ADDENDUM NUMBER I

DATE: February 9, 2026

PROJECT: Newark Valley Central School District 2023
Capital Project – Phase III
High School Air Conditioning

SHEET NO.	
M204-AD1	
PROJECT NO.	
1823.24221.1.3	
DATE:	02/09/2026
AD FILE NO.:	High_School_RVT24.rvt

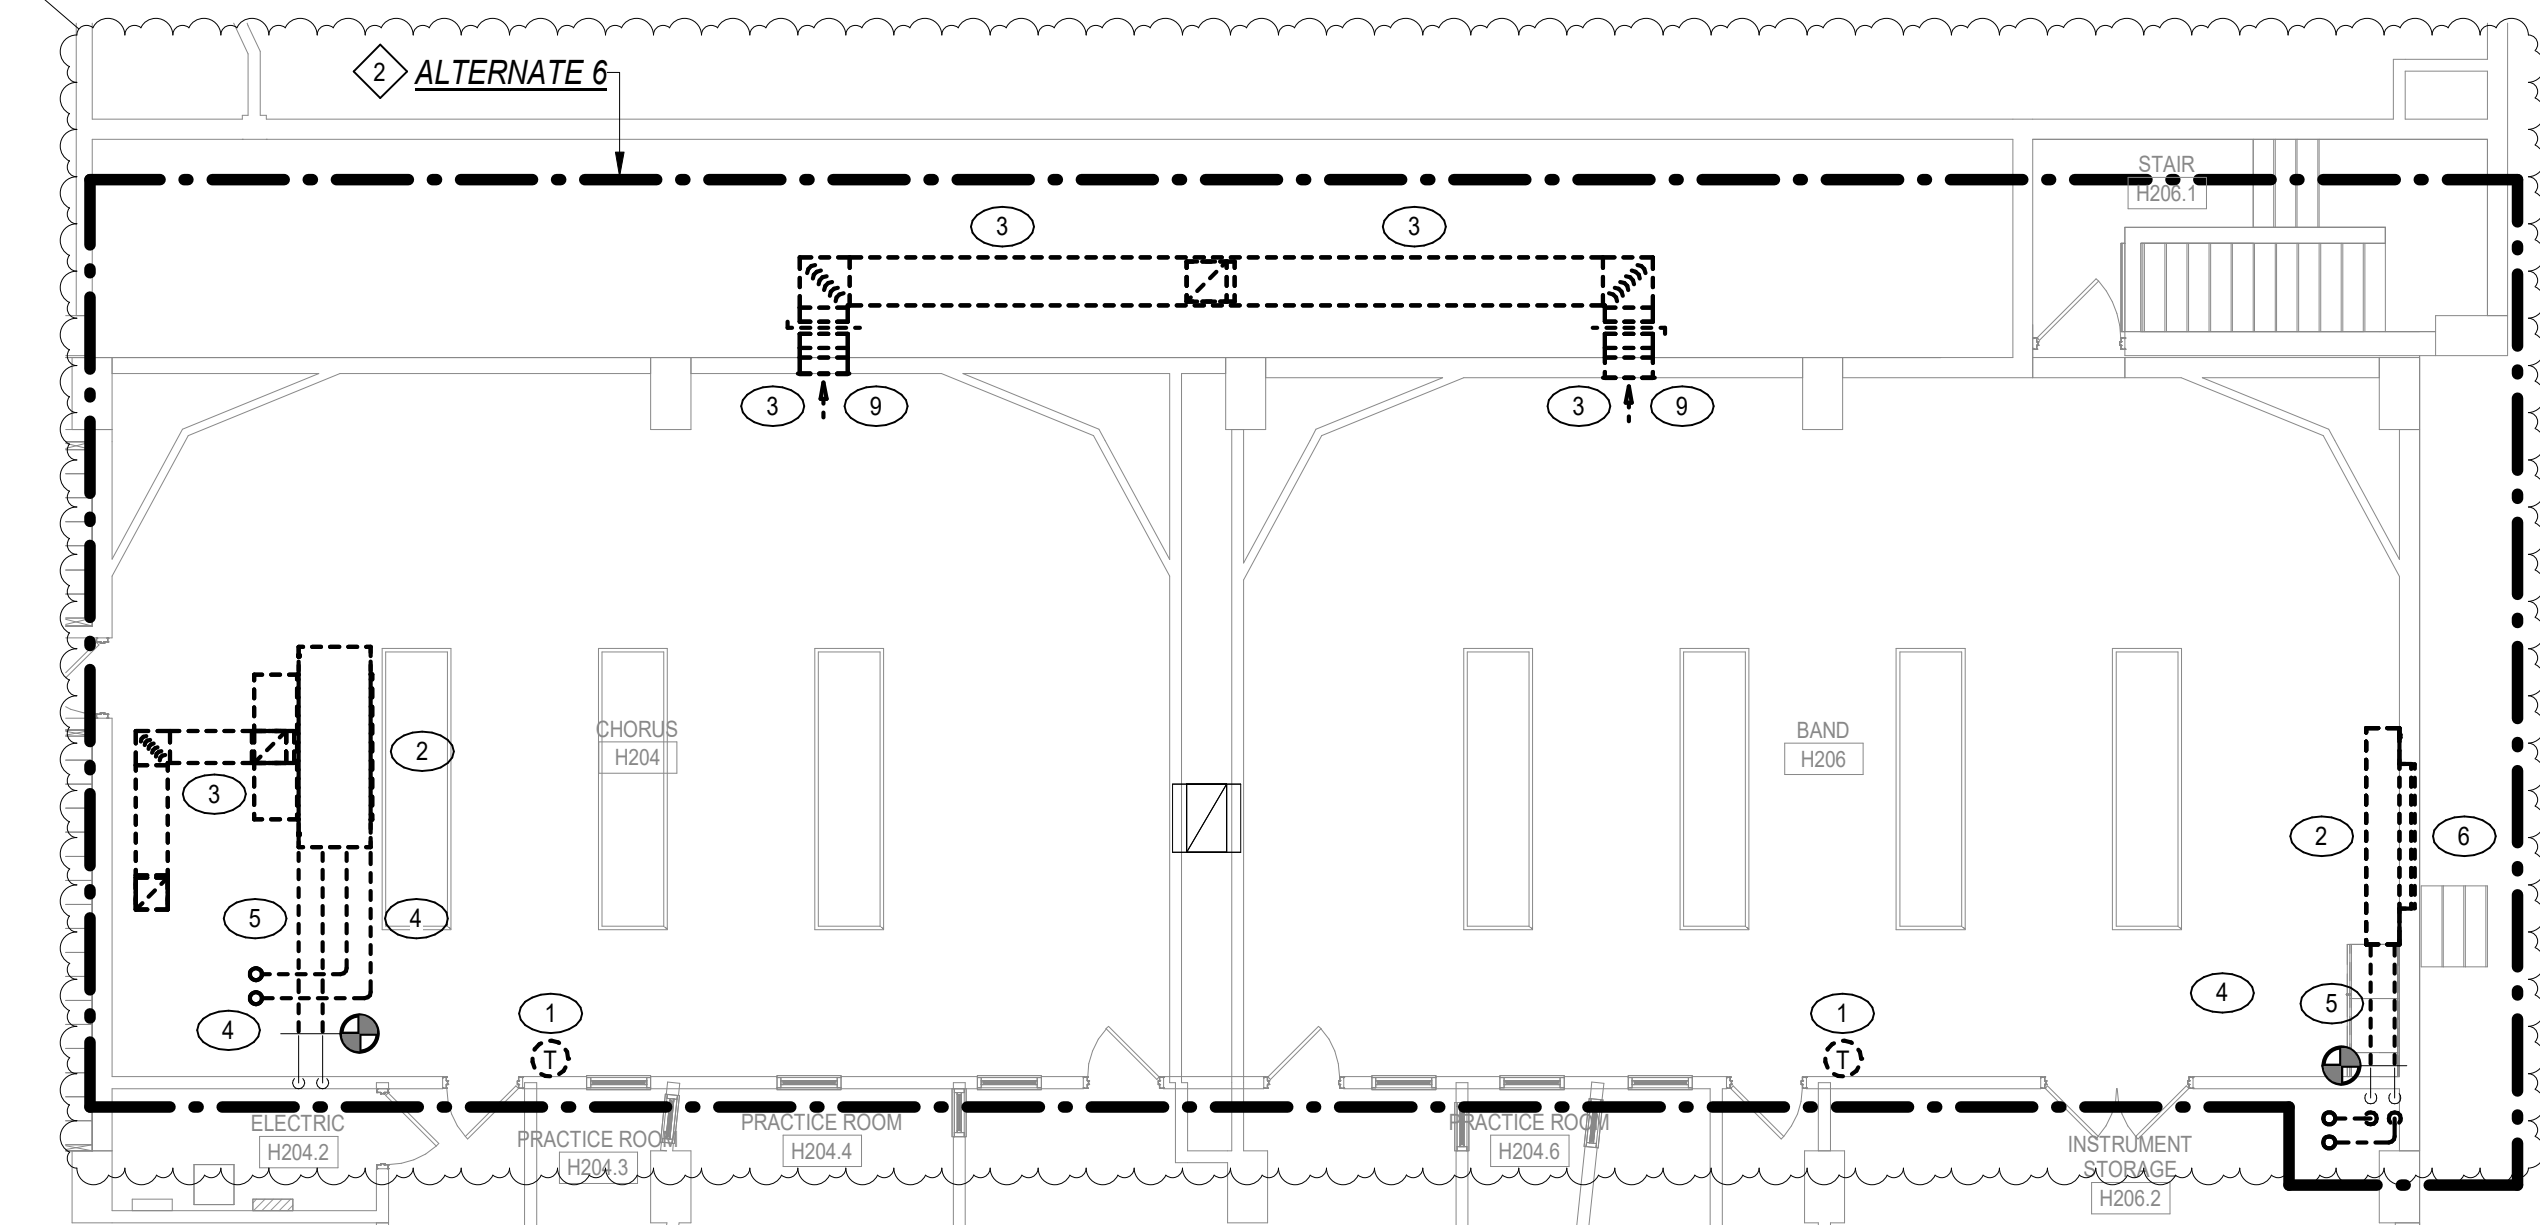
11. M204 - FIRST FLOOR MECHANICAL REMOVAL PLAN - AREA 3

- a. ADD removals and removal notes as shown on the attached drawing M204-ADI.

SHEET NO.
1205-AD1
PROJECT NO.
1823.24221.1.3
02/09/2026
FILE NO.: High School_RVT24.rvt

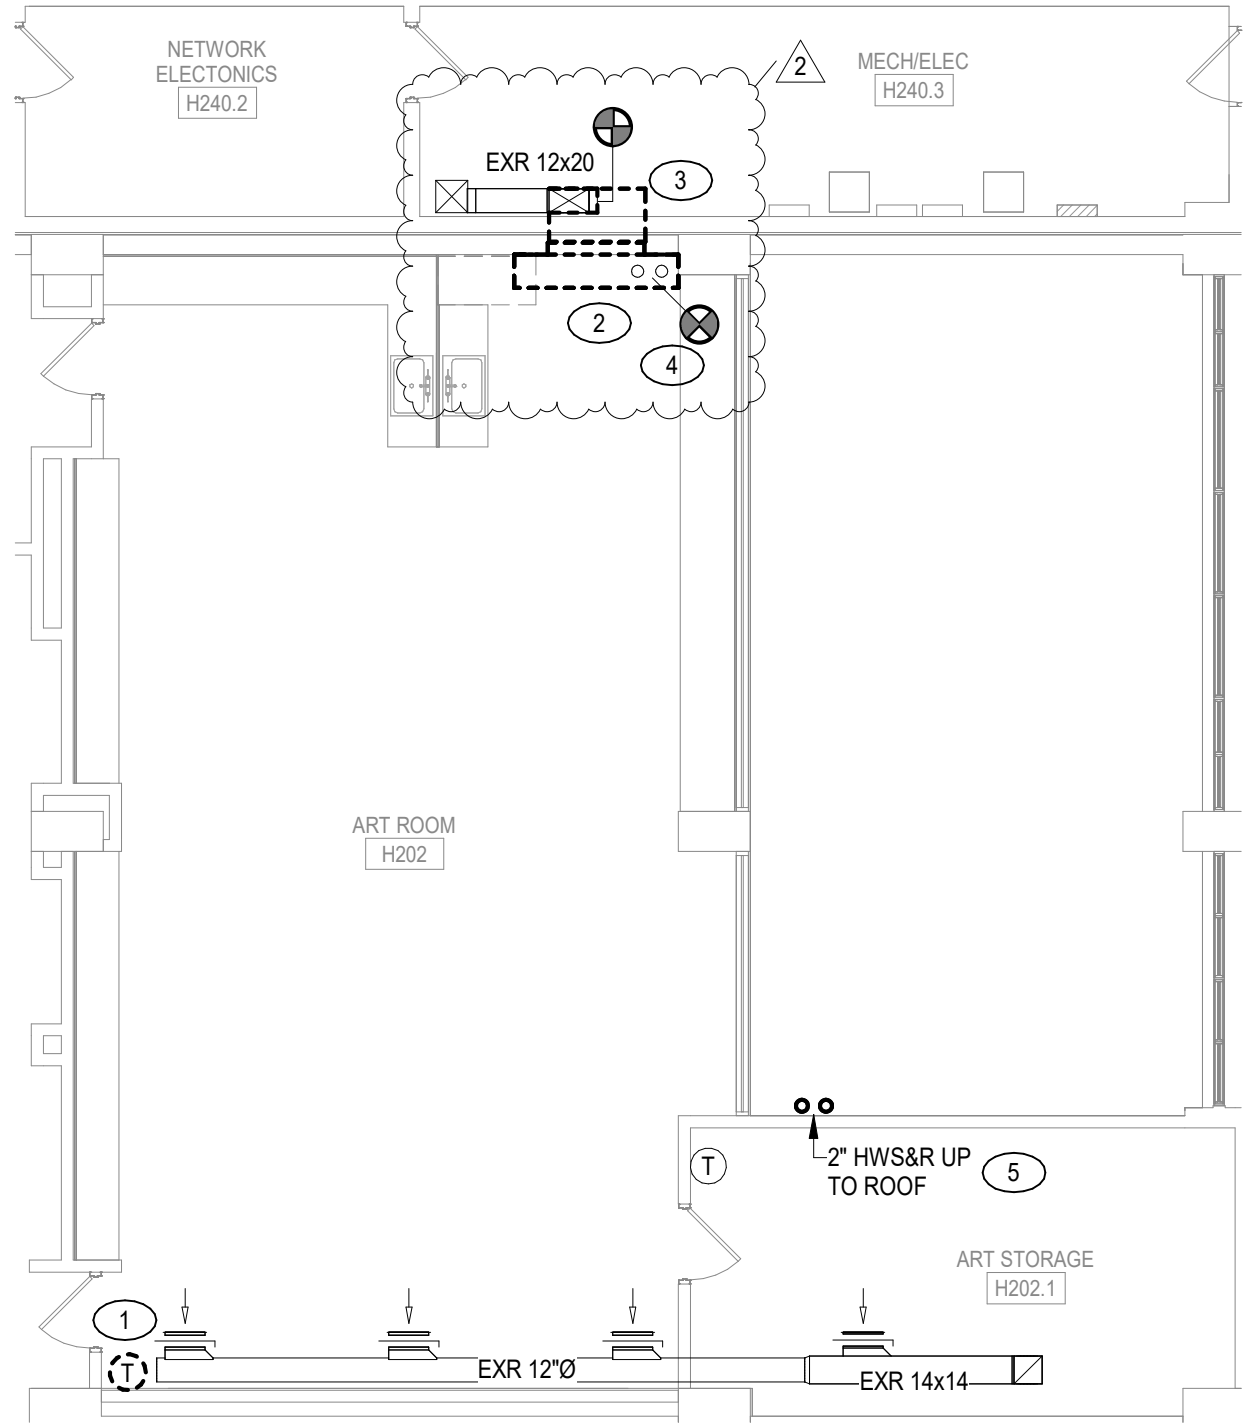
12. M205 - SECOND FLOOR MECHANICAL REMOVAL PLAN - AREA 1
 - a. REVISE Chorus and Band rooms as shown on the attached drawing M205-ADI.
13. M206 - SECOND FLOOR MECHANICAL REMOVAL PLAN - AREA 2

1 ROOF MECHANICAL REMOVAL PLAN - AREA 1 REVISION
M208-AD1 1/8" = 1'-0"

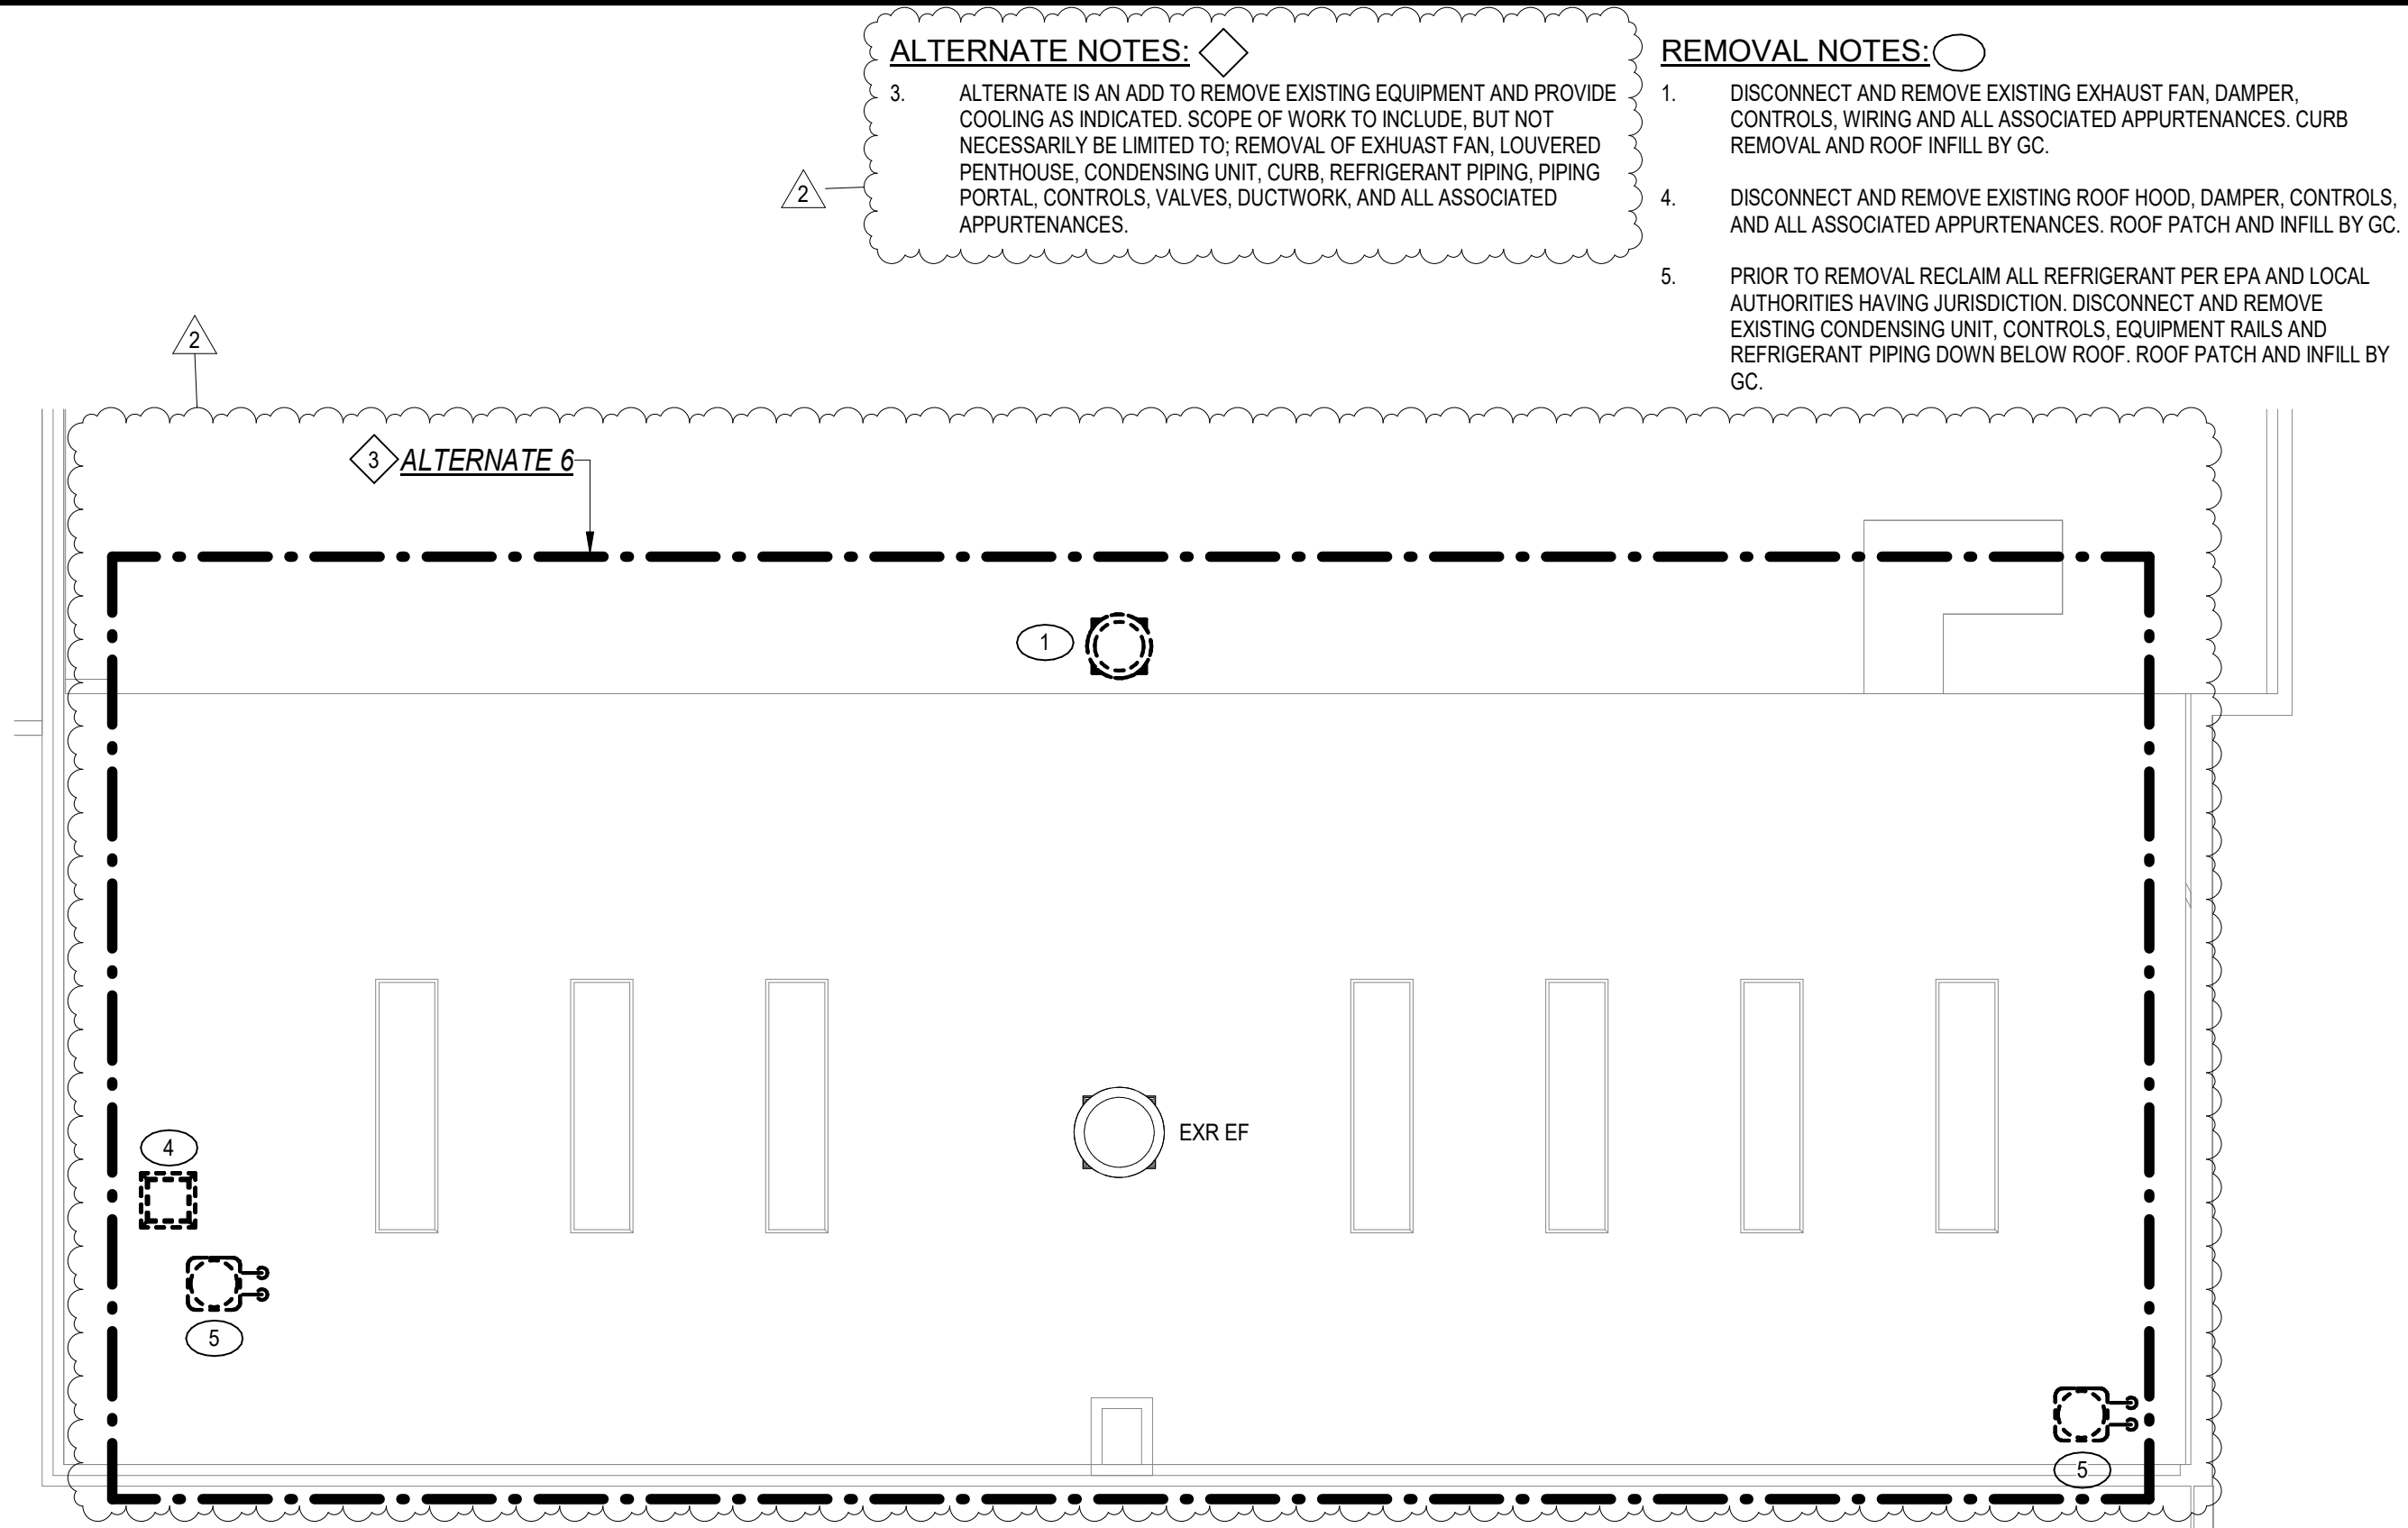
- a. REVISE as shown on the attached drawing M206-ADI.
14. M208 - ROOF MECHANICAL REMOVAL PLAN - AREA 1
 - a. REVISE as shown on the attached drawing M208-ADI.

SHEET NO.
1303-AD1
PROJECT NO.

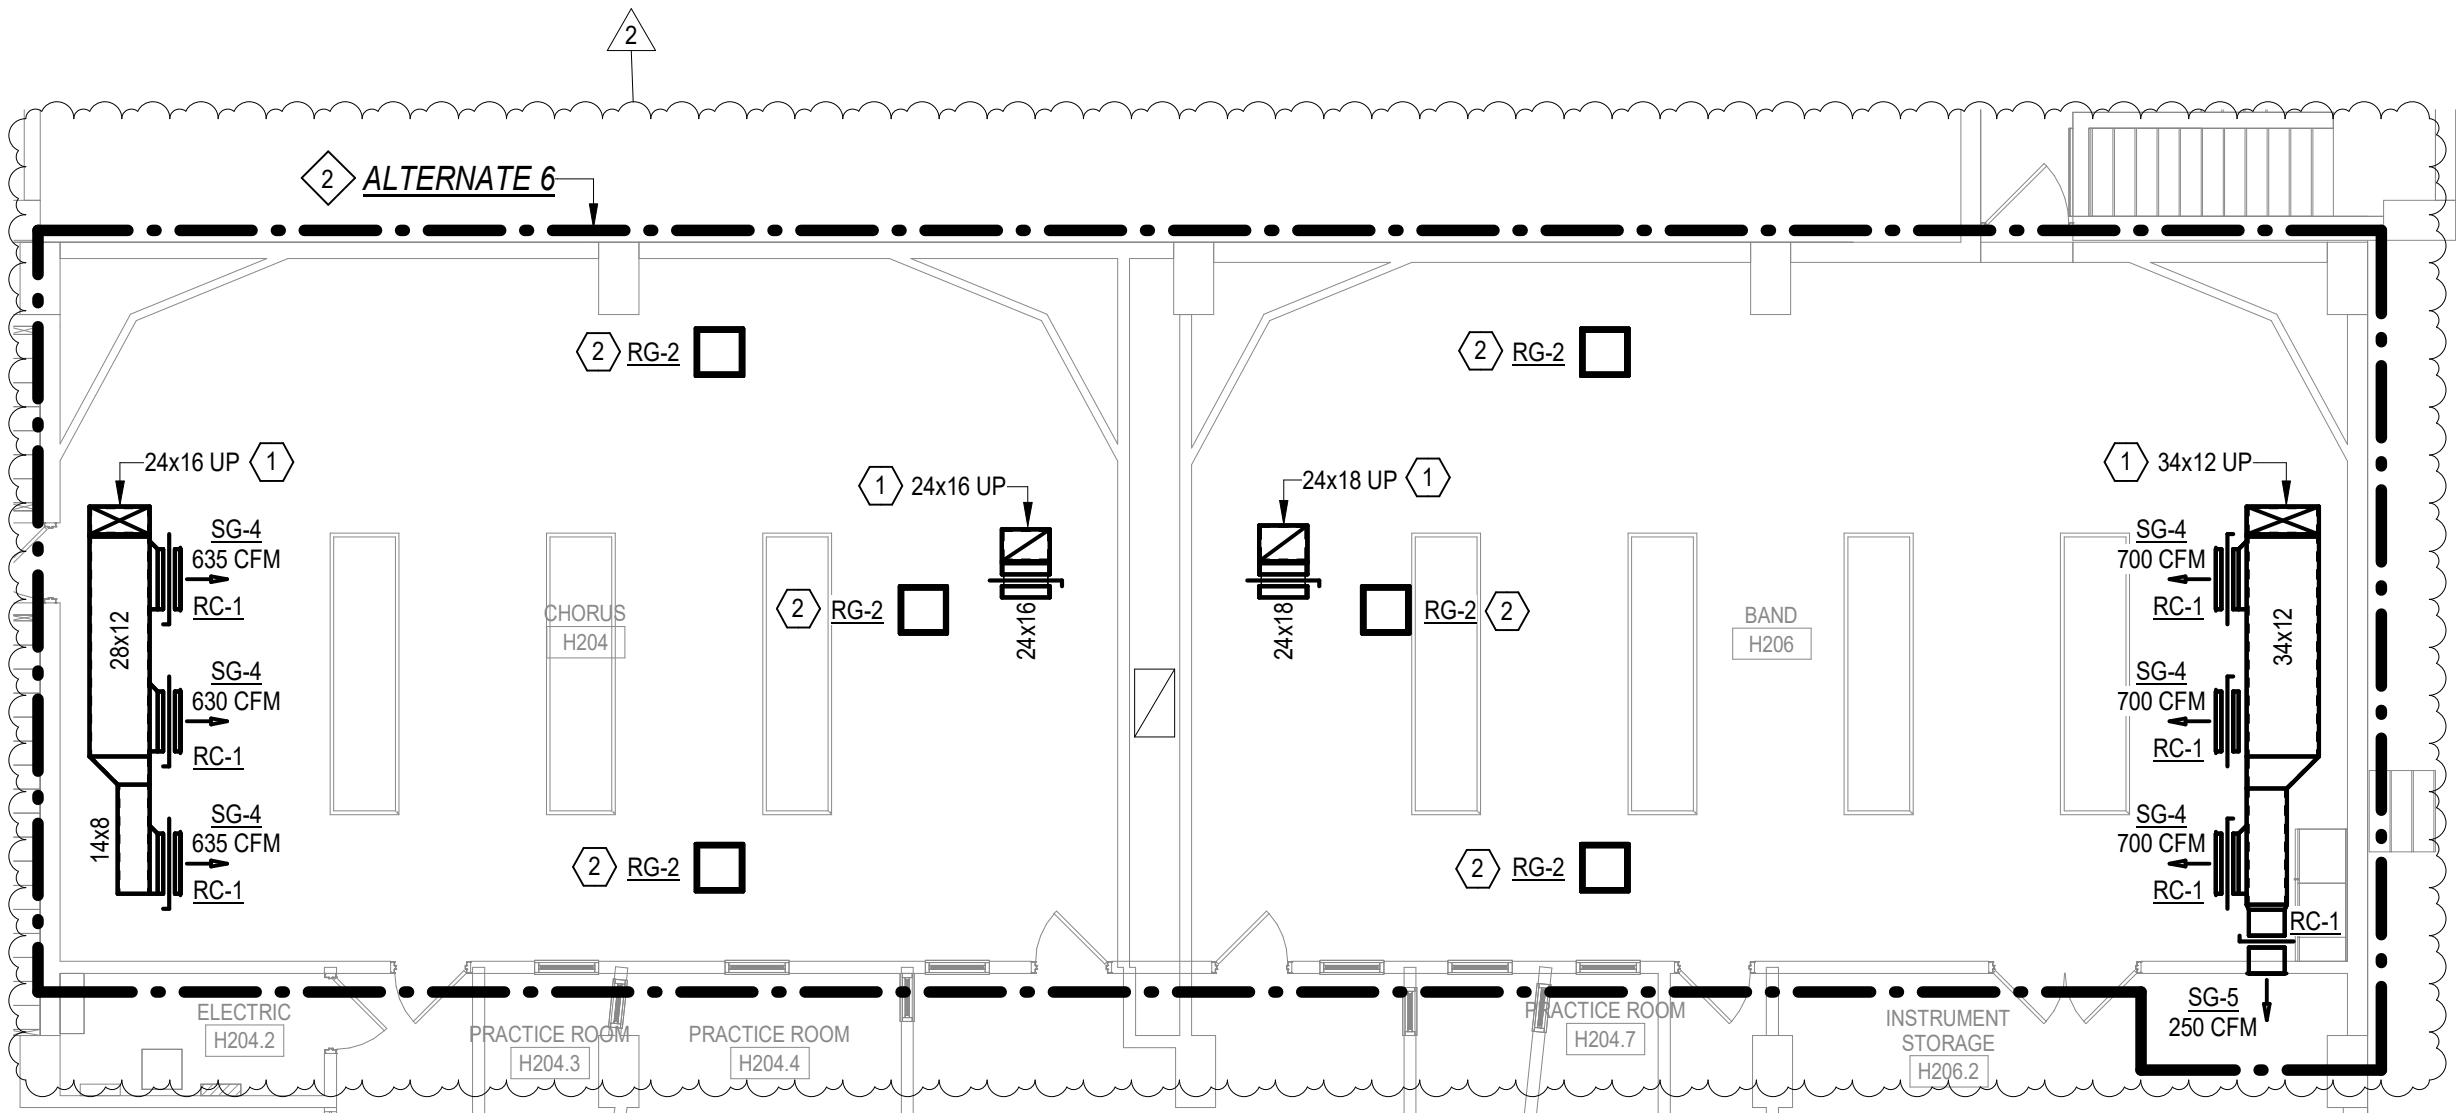
15. M301 - FIRST FOOR DUCT PLAN - AREA 1
 - a. REVISE as shown on the attached drawing M301-ADI.
16. M303 - FIRST FLOOR DUCT PLAN - AREA 3
 - a. REVISE as shown on the attached drawing M303-ADI.
